Addendum to AA Screening and EcIA for Shanganagh Park 1 (Part 8) proposed amendments.

Altemar are the appointed ecologists for the proposed development of park improvement works at Shanganagh Park 1 (Part 8).

Figure 1. General Arrangement.

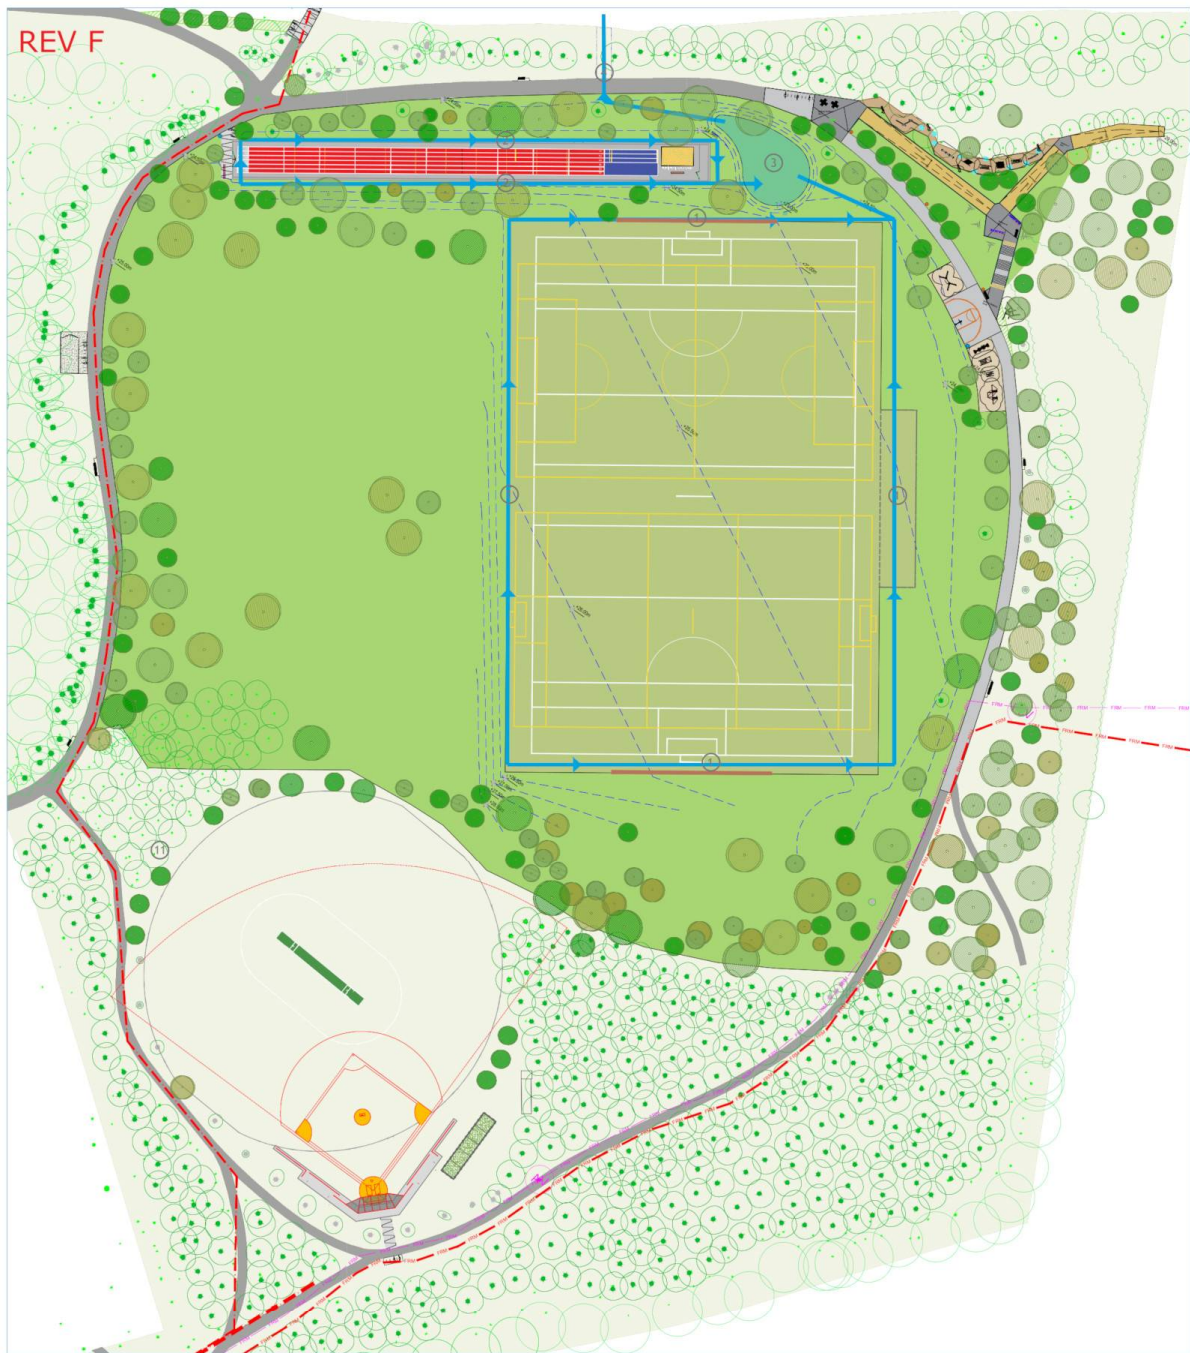
- 2) The movement of the pitch has resulted in the retention of stands of trees that were to be removed previously. This would be seen as a positive step for the project and biodiversity. As seen from Figure 1 further tree planting is proposed.

Figure 3. Light spill assessment

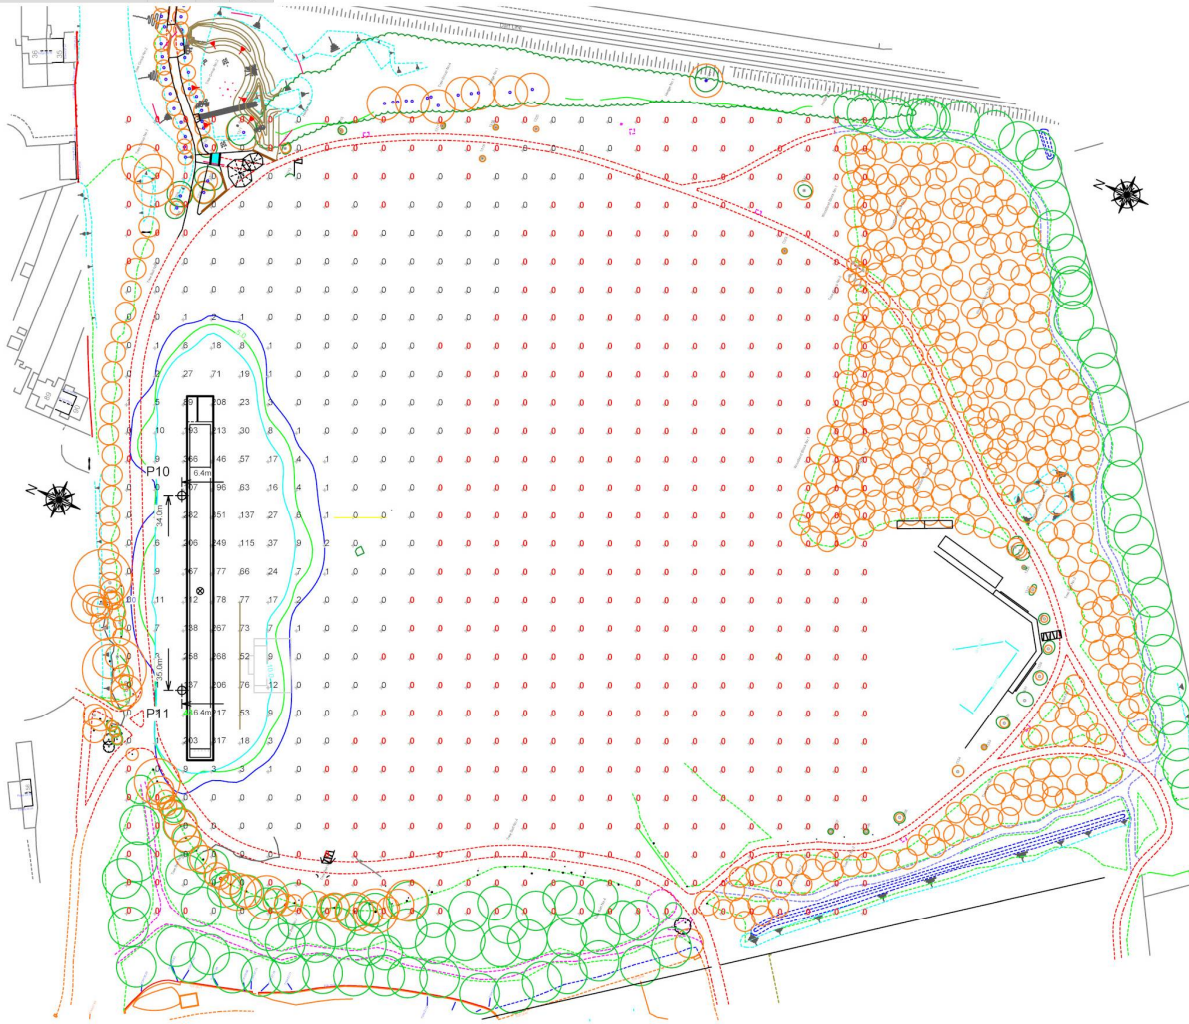
The updated lighting with 2 lux (dark blue), 5 lux (green) 10 lux (light blue) isolines at 100% power at 2m high are seen in Figure 3. The project revision has restricted lighting to the track only, with no lighting on the pitch. There is very limited light spill, no greater than 2 lux, onto the existing lit footpath. However, lighting does extend onto the grassland beside the track but this would not be seen to be significant for bats. This lighting was in place in the previously approved project. In addition, the same seasonal lighting timing constraints will be in place as outlined in the bat assessment. Overall the modifications are seen as positive for bats.
